REPORT TO CITY COUNCIL

SUBJECT: APPEAL OF THE PLANNING COMMISSION'S APPROVAL OF SITE PLAN/ARCHITECTURAL REVIEW CASE NO. 06-SPR-009, OAK TREE PERMIT CASE NO. 06-OTP-021 AND A VESTING TENTATIVE PARCEL MAP CASE NO. VTPM 67397, WHICH ALLOWS FOR THE CONSTRUCTION OF A NEW 9,658 SQUARE-FOOT, ONE-STORY PROFESSIONAL OFFICE BUILDING AND A 20,002 SQUARE-FOOT, TWO-STORY MEDICAL OFFICE BUILDING ON A PARTIALLY DEVELOPED SITE AT 27489 AGOURA ROAD; AN OAK TREE PERMIT TO ENCROACH INTO THE PROTECTED ZONE OF 27 OAK TREES DURING THE CONSTRUCTION AND TO REMOVE 12 OAK TREES FOR THE PROPOSED DEVELOPMENT; A VESTING TENTATIVE PARCEL MAP TO MERGE SIX (6) PARCELS INTO A SINGLE PARCEL; AND A MITIGATED NEGATIVE DECLARATION AND MITIGATION MONITORING PROGRAM (APPLICANT: 27489 AGOURA ROAD, LLC)

**OFFICE DEVELOPMENT
FOR THE PROPERTY LOCATED
AT 27489 AGOURA ROAD,
AGOURA HILLS**

**SITE PLAN/ARCHITECTURAL REVIEW CASE NO. 06-SPR-009
OAK TREE PERMIT CASE NO. 06-OTP-021
VESTING TENTATIVE PARCEL MAP 67397**

TREE #1

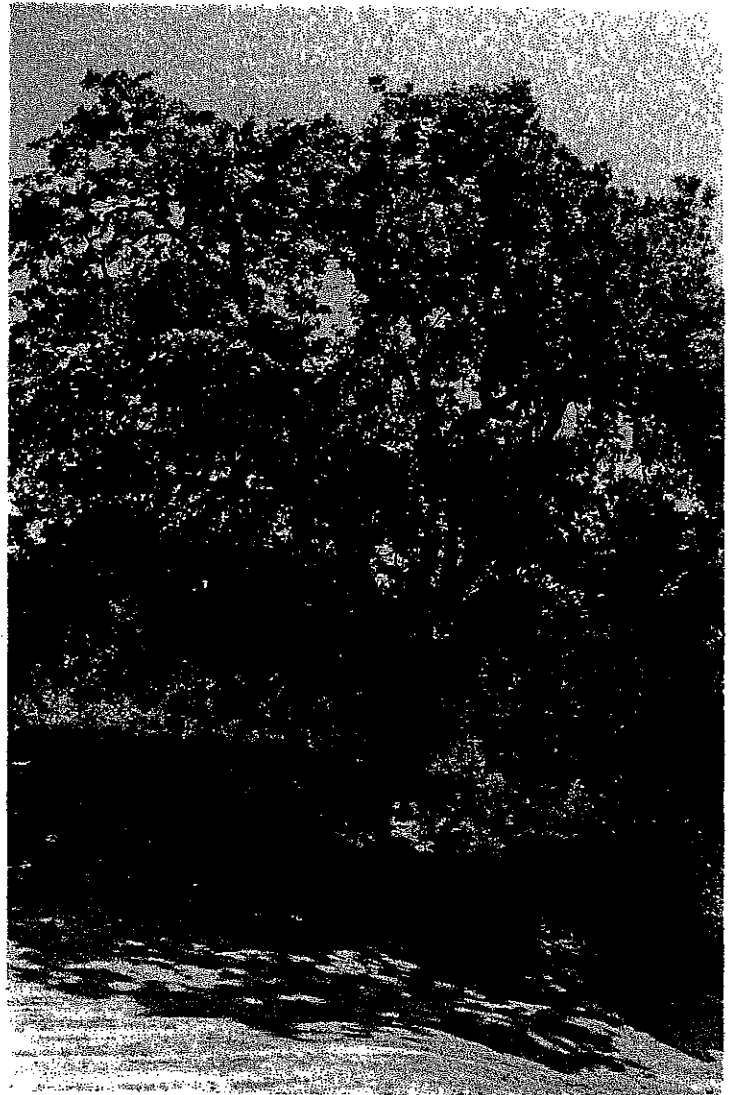
Will definitely be removed for widening of Liberty Canyon Blvd and sidewalk.

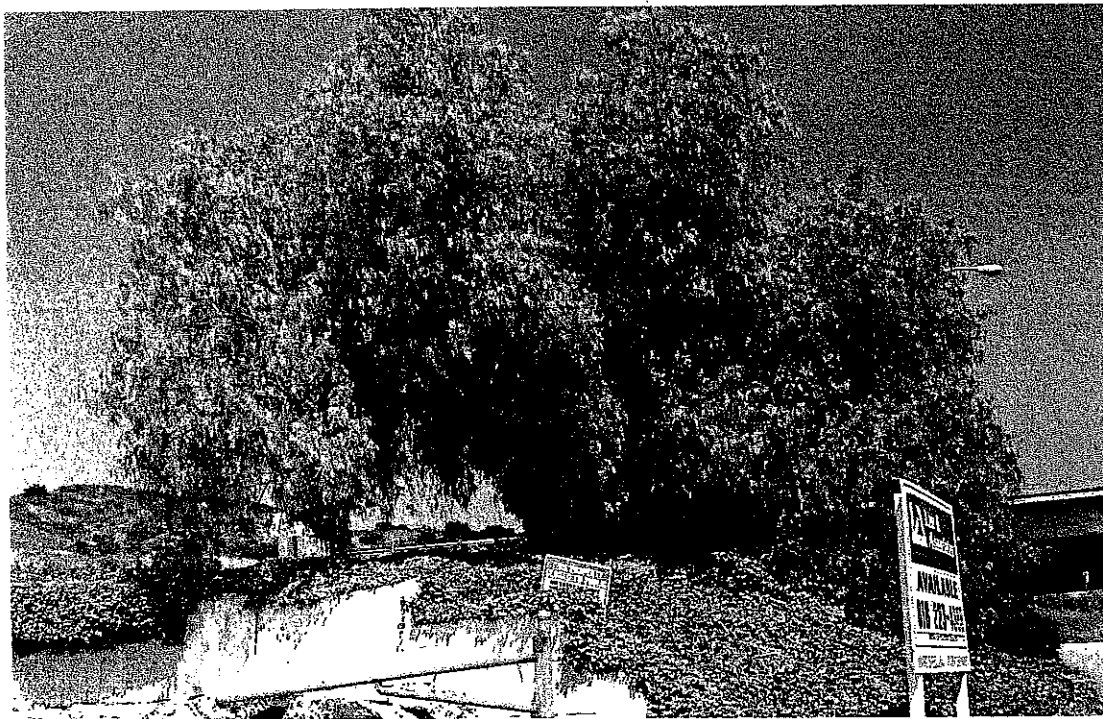
Tree #2: May also be removed for street widening and sidewalk.
